E/ECE/324
E/ECE/TRANS/505 } Add.8/Rev.2/Amend.1

Addendum 8: Regulation No. 9

Revision 2 - Amendment 1

UNIFORM PROVISIONS CONCERNING THE APPROVAL OF CATEGORY L2, L4 AND L5 VEHICLES WITH REGARD TO NOISE

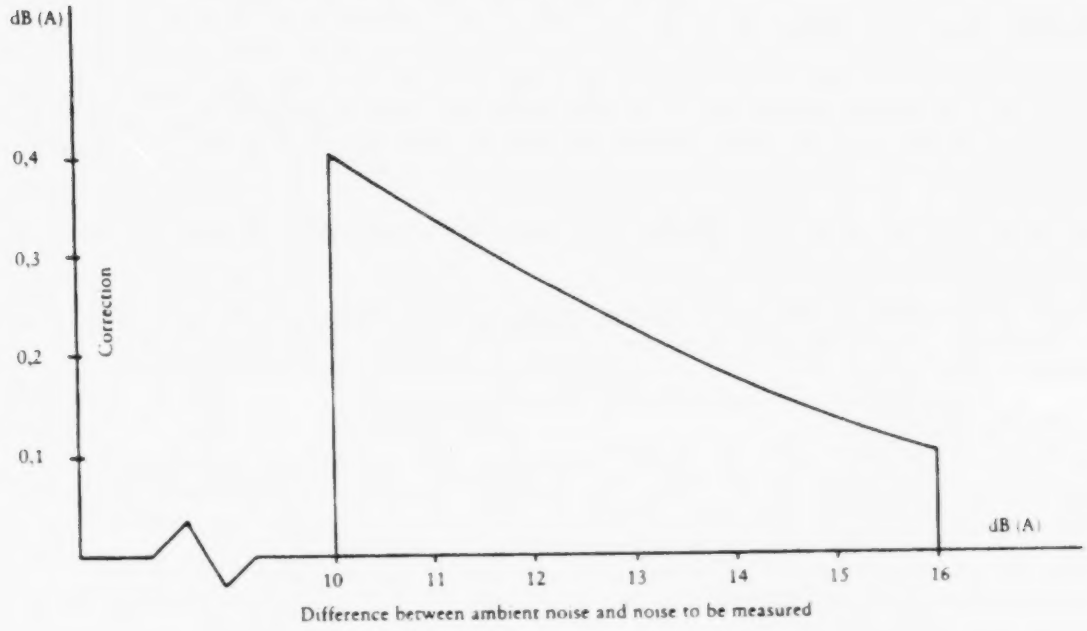
Paragraph 2.3., amend to read:

If the difference between ambient and measured noise-levels is between 10 and 16 dB(A), the appropriate figure shall be subtracted from the value recorded by the sound-level metre, in accordance with the following graph:

Figure 1

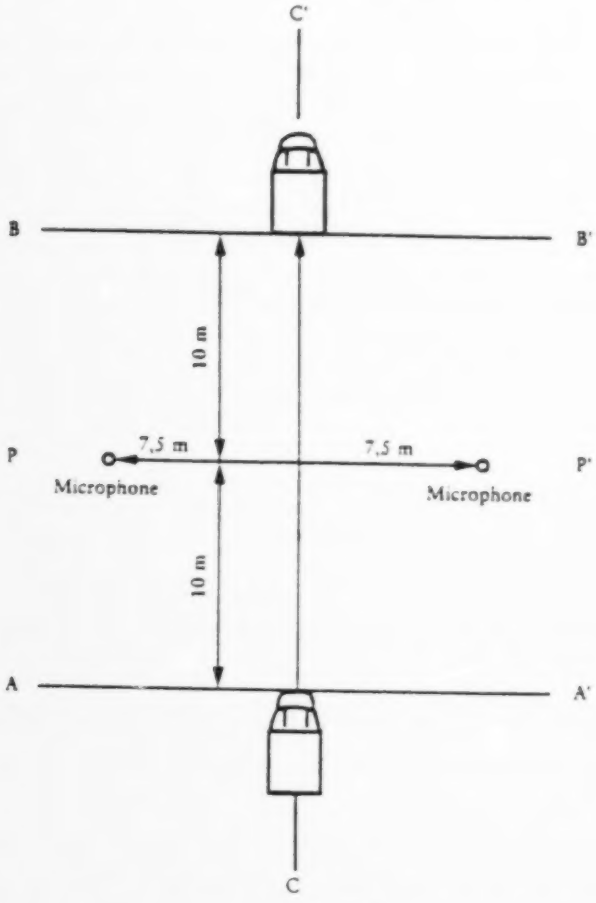
Annex 3 - Appendix, amend to read:

Figure 3

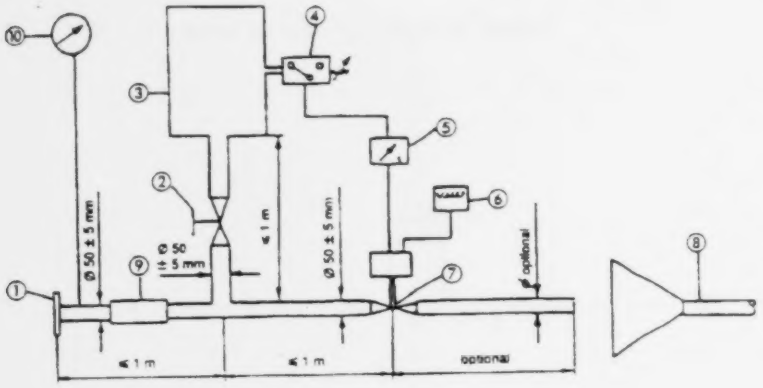
The test apparatus, a detailed diagram of which is shown in Figure 3, shall be fitted at the outlet of the exhaust system. Any other apparatus providing equivalent results shall be acceptable.

Figure 1: Minimum requirement for test surface area. The shaded part is called "Test Area".

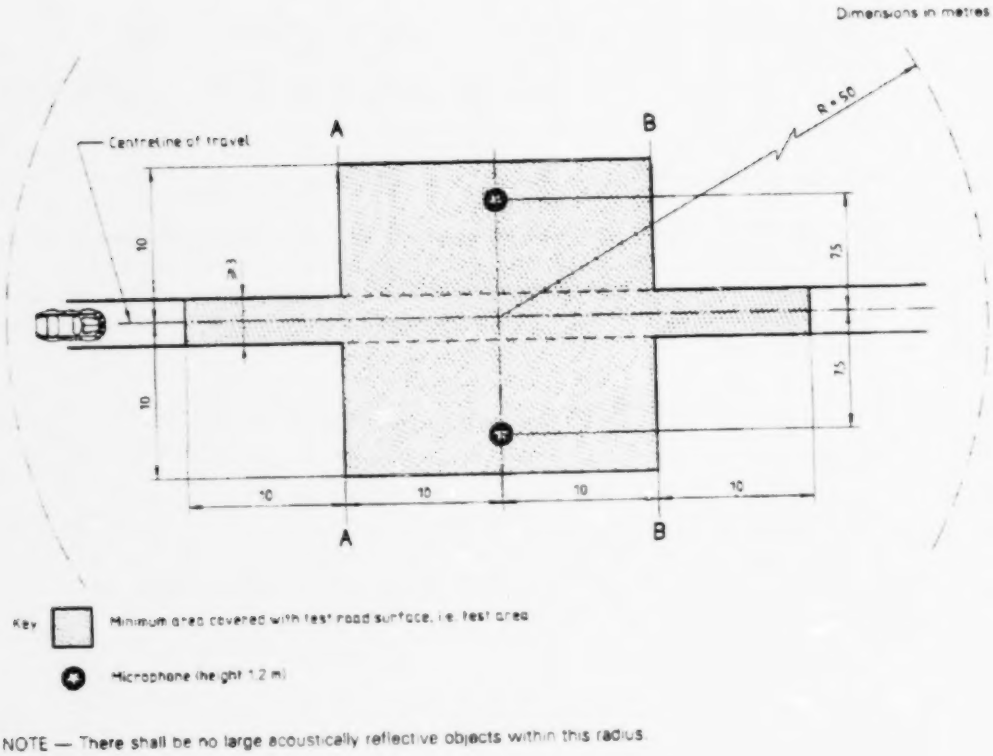
When designing the test track layout it is important to ensure that, as a minimum requirement, the area traversed by the vehicles running through the test strip is covered with the specified test material with suitable margins for safe and practical driving. This will require the width of the track to be at least 3 m and the length of the track to extend beyond lines AA and BB by at least 10 m at either end. Figure 1 shows a plan of a suitable test site and indicates the minimum area which shall be machine laid and machine compacted with the specified test surface material. According to annex 3,

If it is necessary to repave the test track, it is usually unnecessary to repave more than the test strip (of 3 m width in Figure 1) where vehicles are driving, provided the test area outside the strip met the requirement of residual voids content or sound absorption when it was measured.

Figure 2: Grading curve of the aggregate in the asphaltic mix with tolerances.

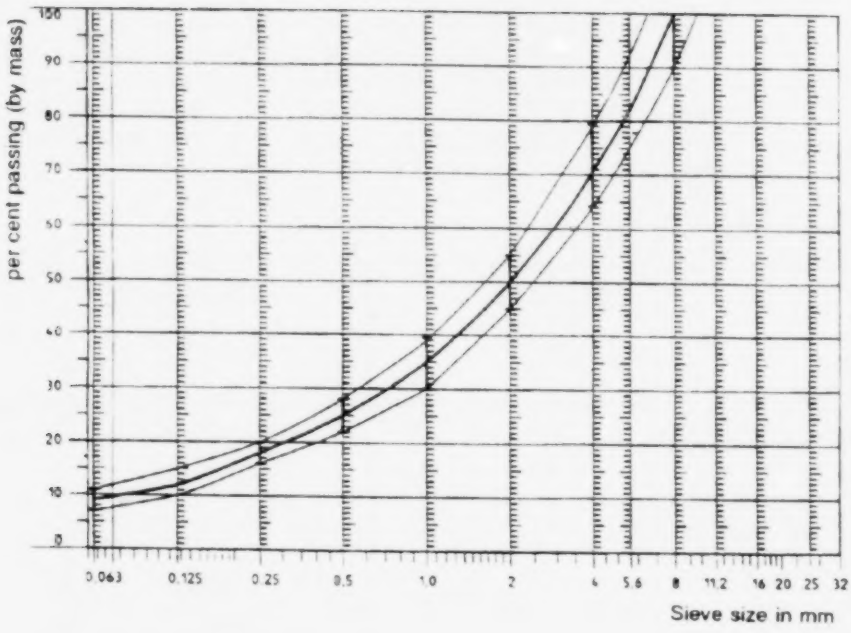
As a guide to the surface constructor, an aggregate grading curve which will give desired characteristics is shown in Figure 2. In addition, Table 1 gives some guidelines for obtaining the desired texture and durability. The grading curve fits the following formula:
